Illinois Department of Transportation

SUBJECT: Quad City International Airport
Moline, Illinois
Rock Island County
Illinois Project Number: MLI-4359
AIP Project Number: 3-17-0068-XX
Contract No. QU018
Item No. 4A, August 1, 2014 Letting
Addendum A

NOTICE TO PROSPECTIVE BIDDERS

Revisions based on phasing direction from the FAA. Clarification of sign removal/disposal requirements. Clarification of light adjustment due to grading.

Reissue Plan Sheet 2, **Site Plan**

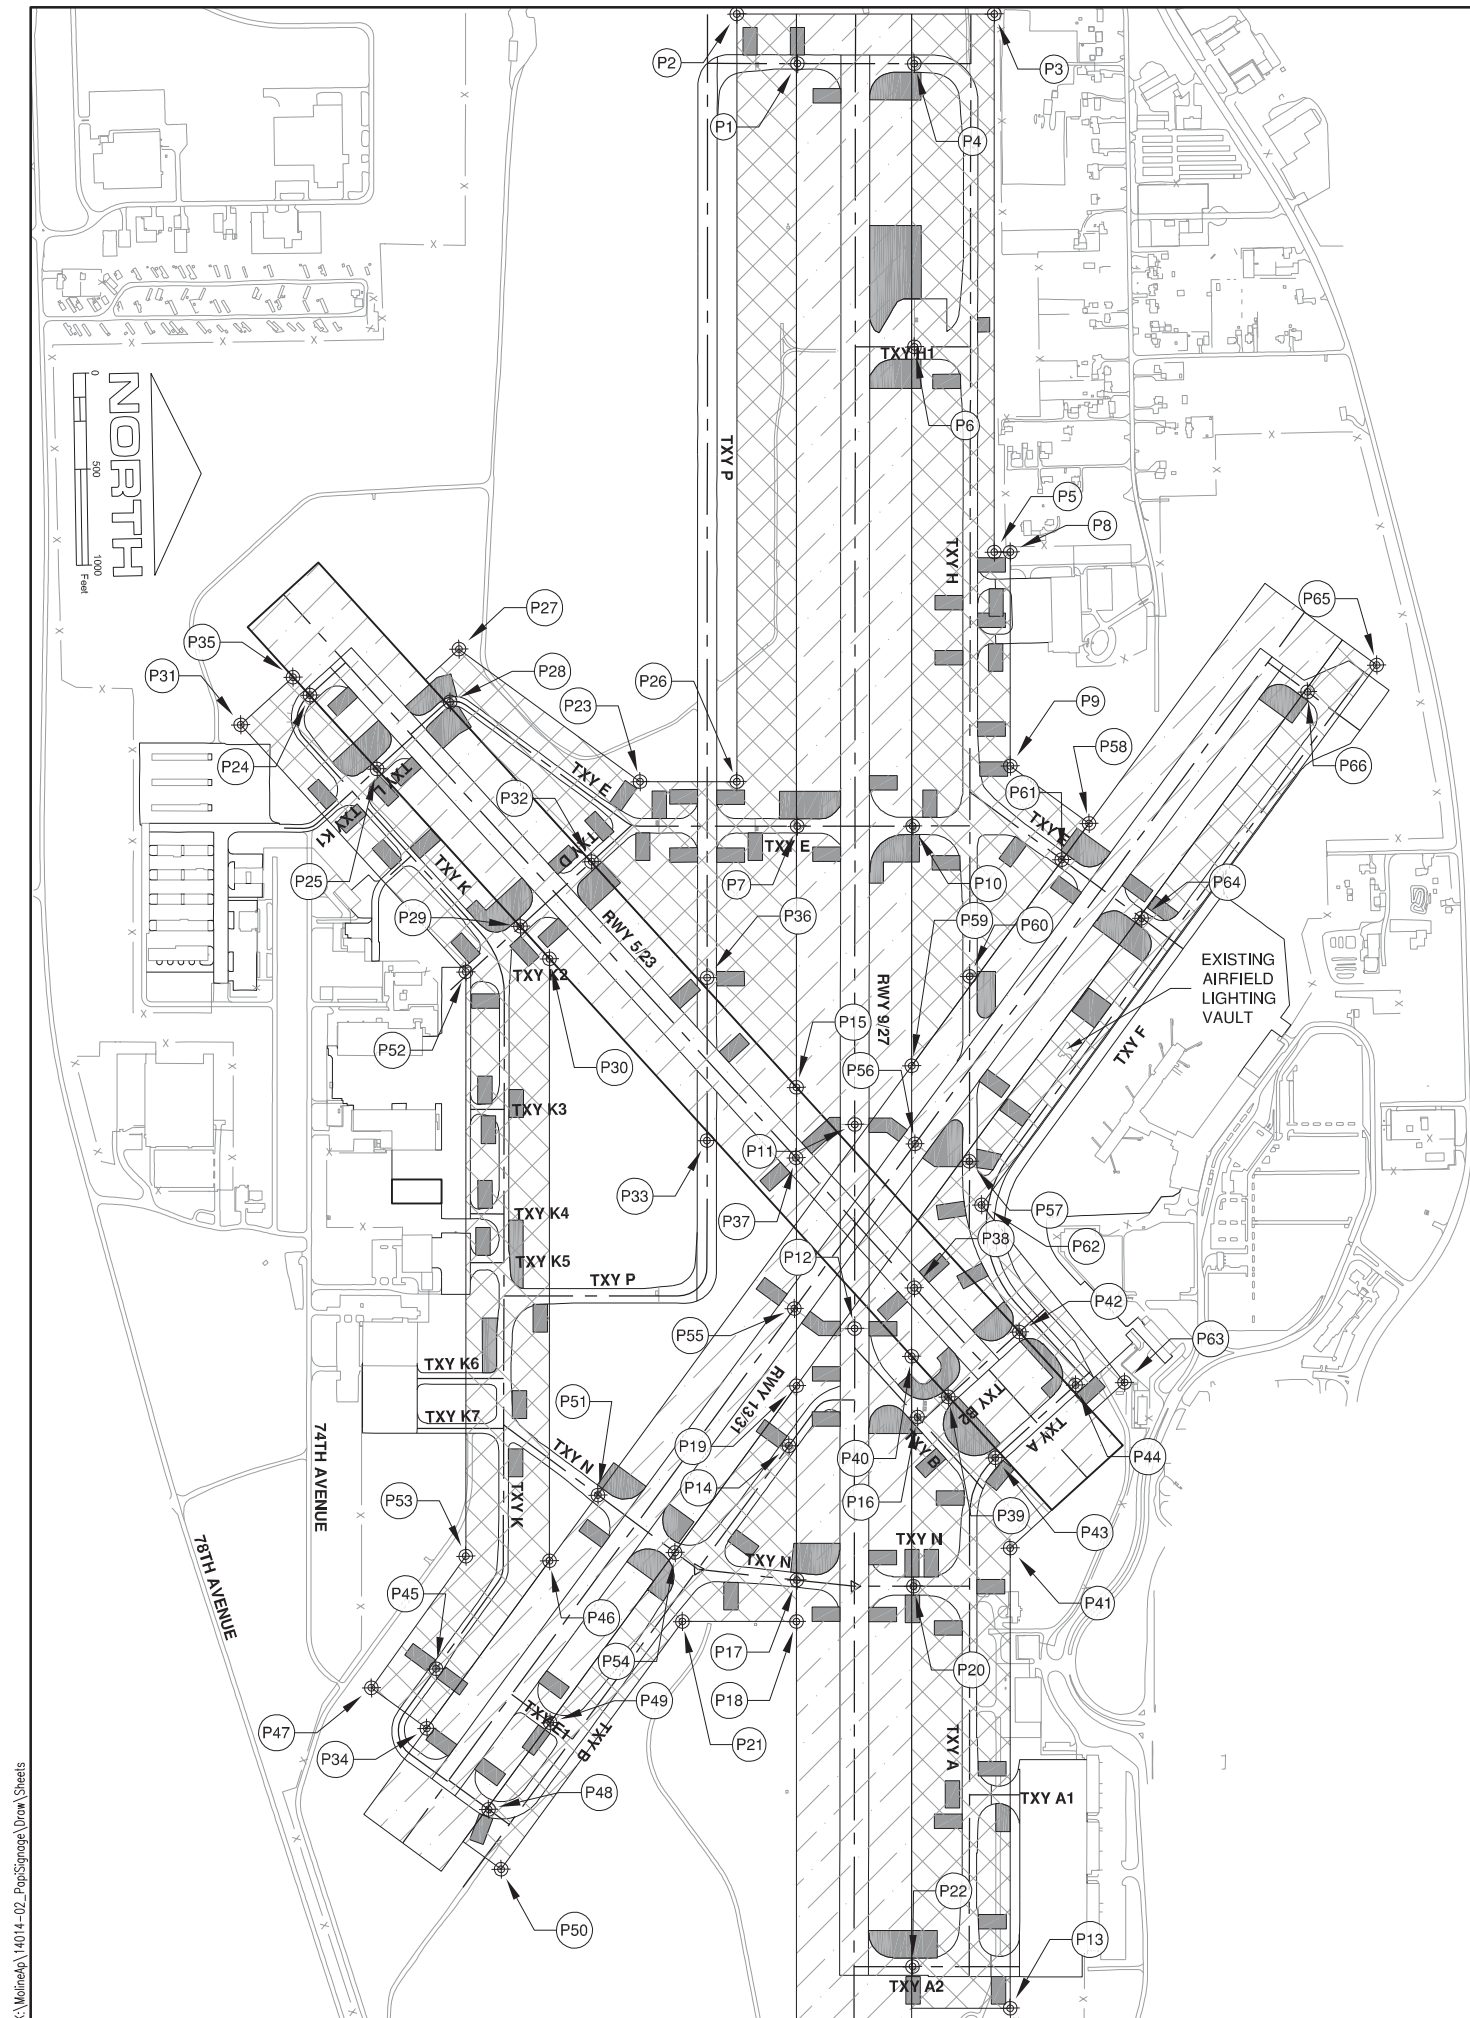
- Revised Notes

- NOTES:**
- ALL TAXIWAYS, TAXILANES, AND RUNWAYS OUTSIDE THE IMMEDIATE WORK LIMITS SHALL REMAIN OPEN FOR THE DURATION OF THE WORK.
 - PRIOR TO BEGINNING WORK EACH DAY, THE CONTRACTOR SHALL PLACE ALL BARRICADES AT THE TAXIWAY OBJECT FREE AREA OR RUNWAY SAFETY AREA LIMITS SHOWN AND AS DESCRIBED IN THE SEQUENCE OF CONSTRUCTION.

- CONTRACTOR'S WORK AREAS SHALL BE COORDINATED WITH THE AIRPORT. THE AIRPORT WILL HAVE THE FINAL SAY IN CONSTRUCTION PHASING AND SEQUENCING.
 - THE CONTRACTOR SHALL NOT BE ALLOWED TO REOPEN PAVEMENTS UNTIL THE CURRENT WORK AREA HAS BEEN RESTORED TO THE SATISFACTION OF THE AIRPORT.

- ALL PAVEMENT CLOSURES AND RE-OPENINGS SHALL BE COORDINATED CLOSELY WITH THE AIRPORT. THE AIRPORT WILL HAVE AUTHORITY OVER THE SCHEDULE FOR OPENING AND CLOSING OF PAVEMENTS.

- RUNWAY CLOSURES SHALL REQUIRE THE USE OF PORTABLE RUNWAY CLOSURE MARKERS TO BE PROVIDED BY THE AIRPORT (SEE DETAIL ON CONSTRUCTION ACTIVITY NOTES AND DETAILS).

- ANY WORK BEING DONE IN THE VICINITY OF EXISTING FAA OR AIRPORT CABLE RUNS SHALL REQUIRE THE PROTECTION OF SAID CABLES. THE COST OF PROTECTING THESE CABLES SHALL BE INCIDENTAL TO THE CONTRACT.

- THE CONTRACTOR SHALL PROVIDE MULTIPLE CREWS AS NECESSARY TO COMPLETE THE WORK WITHIN THE SPECIFIED TIME.
 - WHEN WORKING ON THE AIRFIELD, THE CONTRACTOR'S PERSONNEL SHALL WORK IN A MINIMUM OF 12 HOUR PERIODS EXCEPT WHEN WORKING IN THE INTERSECTION OF THE THREE RUNWAYS. **THE PAPI WORK ALLOWS FOR 72 CONSECUTIVE HOUR CLOSURE. THE PAPI WORK INSIDE OF THE RUNWAY SAFETY AREA MAY BE PERFORMED WHEN WORKING IN WORK AREAS 7A, 6A, 3, 1A, 9A, AND 10A AS SHOWN ON SHEET 02A.**

- THE CONTRACTOR SHALL WORK ADJACENT WORK AREAS WHEN POSSIBLE TO MINIMIZE THE AREA OF PAVEMENT CLOSED. THE AIRPORT RESERVES THE RIGHT TO GROUP WORK AREAS SO AS TO MINIMIZE OPERATIONAL IMPACTS.

- THE CONTRACTOR SHALL NOT BE ALLOWED TO HAVE PAVEMENTS REMAIN CLOSED DURING NON-WORKING HOURS. THE CONTRACTOR SHALL IDENTIFY THE WORK AREAS HE INTENDS TO ADDRESS DURING THE WORK PERIOD; NOTIFY AIRPORT OPERATIONS WHEN READY TO INITIATE PAVEMENT CLOSURE; CLOSE THE ADJACENT RUNWAYS AND/OR TAXIWAYS AS REQUIRED; PERFORM WORK; PREPARE WORK AREA FOR RE-OPENING; COORDINATE OPENING WITH AIRPORT OPERATIONS.

- THE CONTRACTOR SHALL ONLY BE ALLOWED TO CLOSE ONE RUNWAY AT A TIME EXCEPT WHEN WORKING IN THE RUNWAY INTERSECTION(S).

Issue Plan Sheet 2A, **Index to Work Area Limits/Locations**

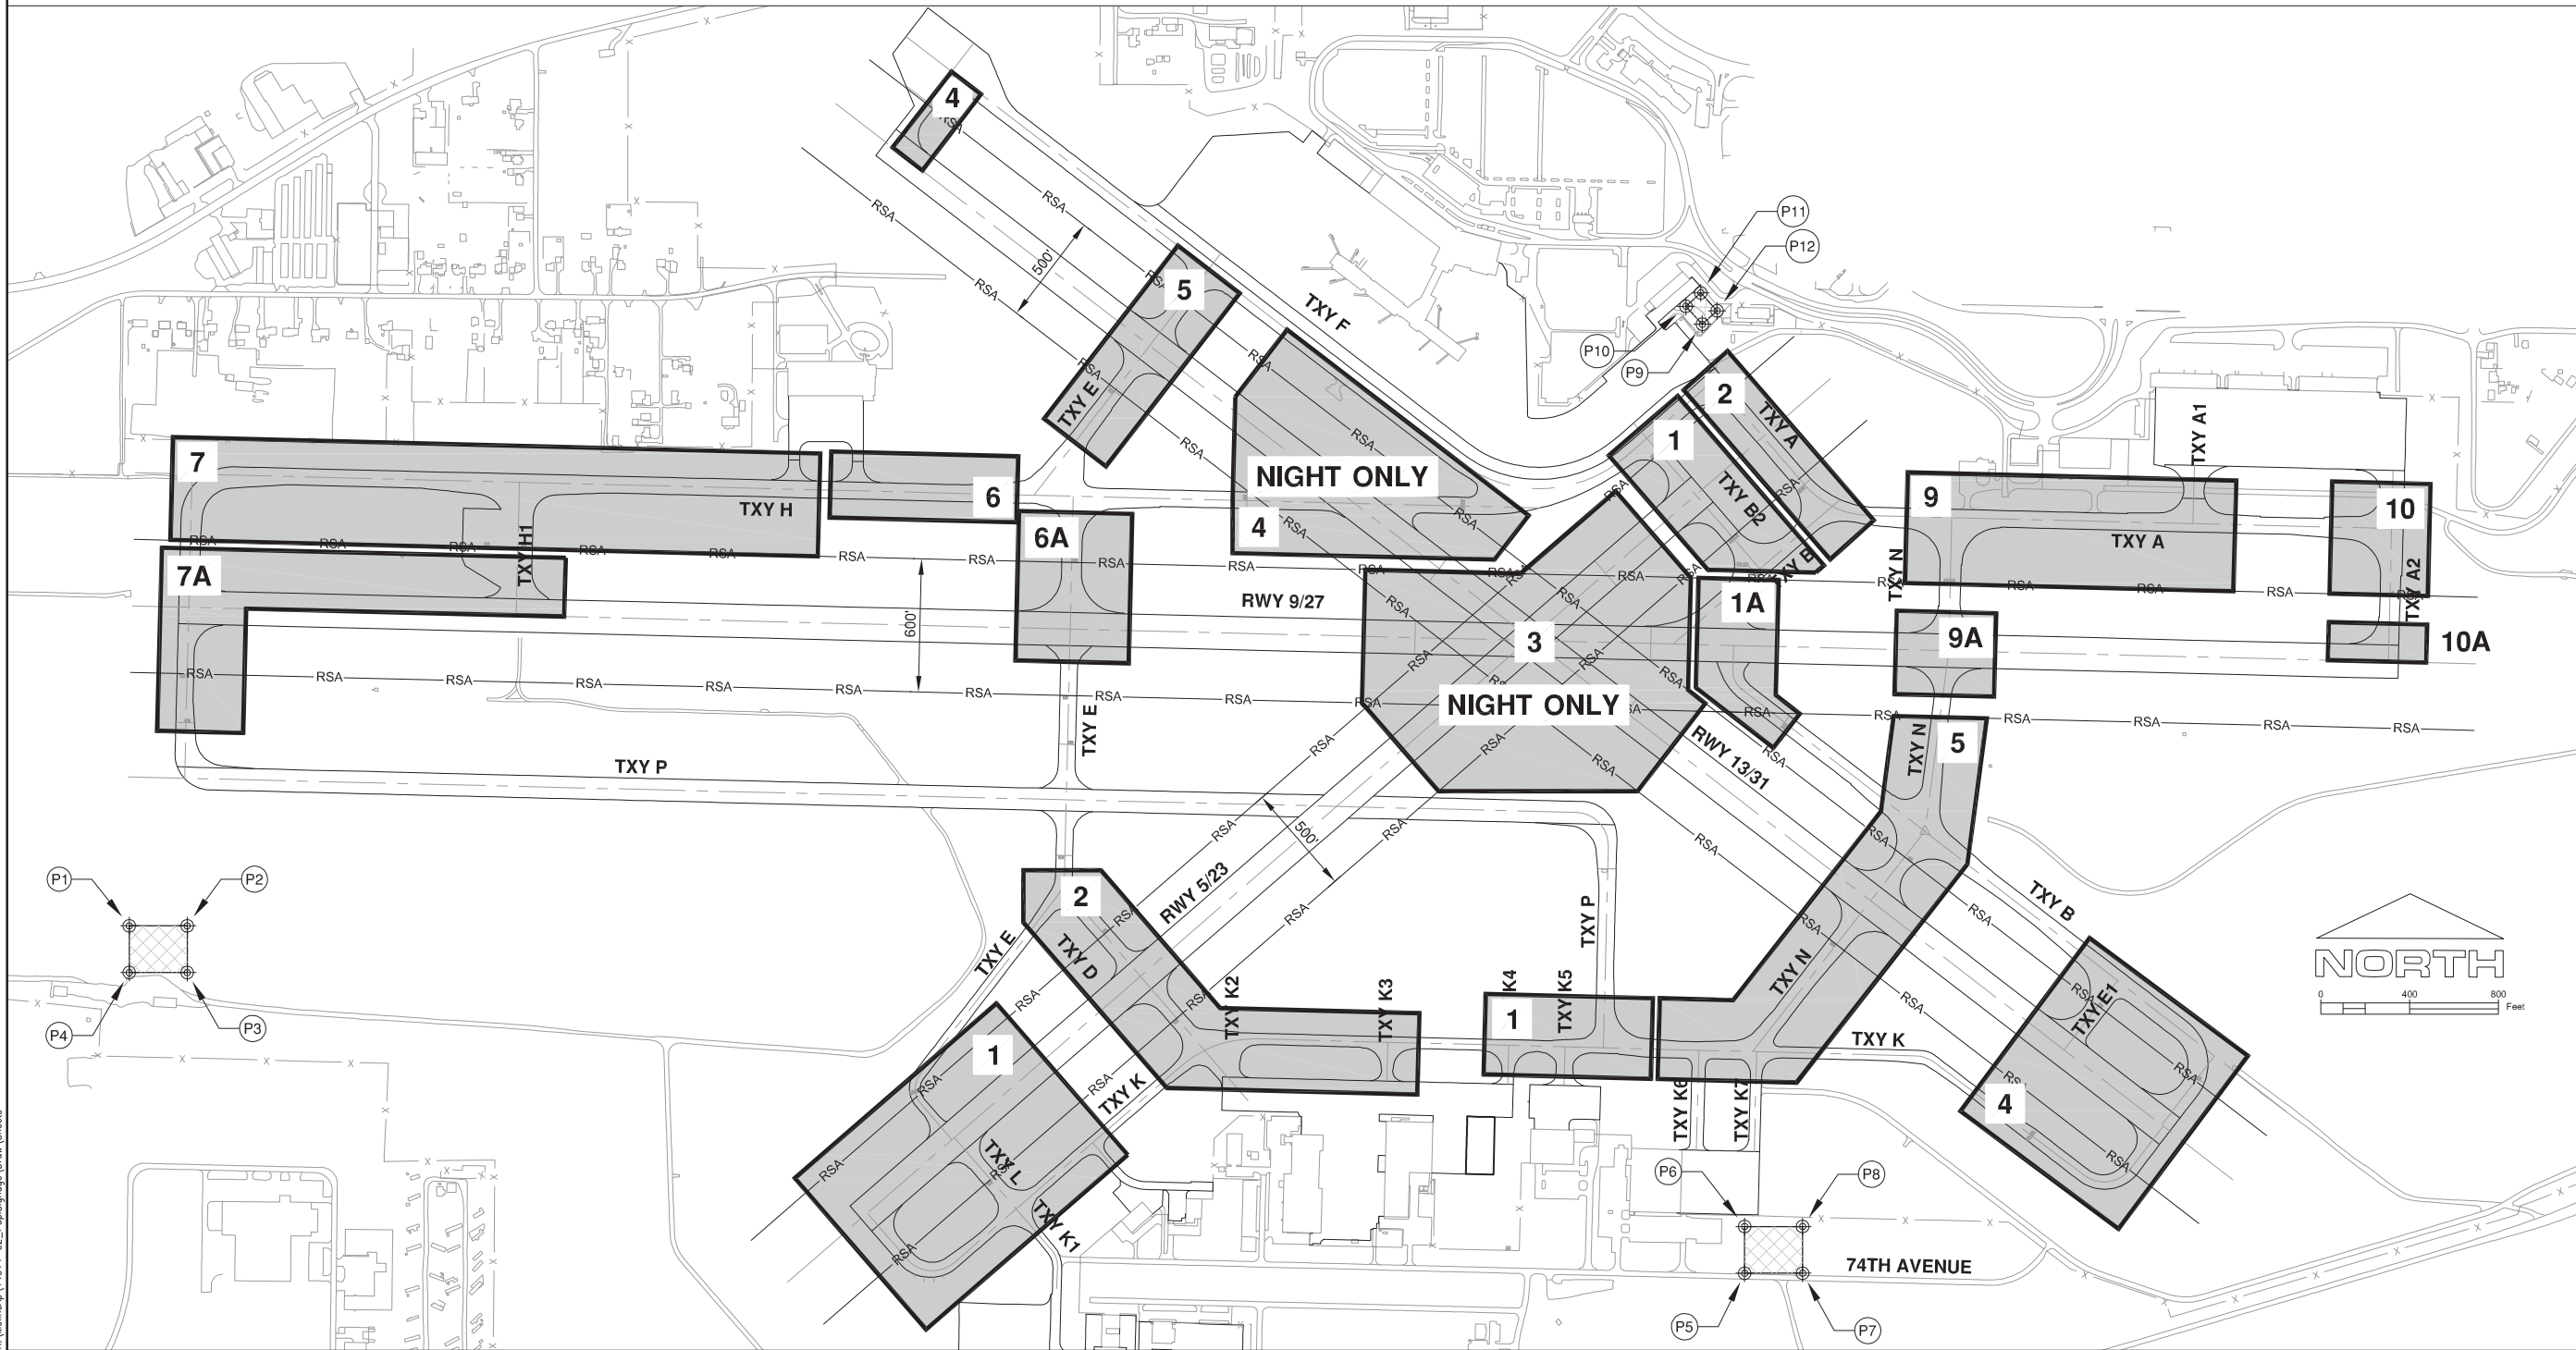
- Sheet shows organized phasing and areas for contractor's staging and storage
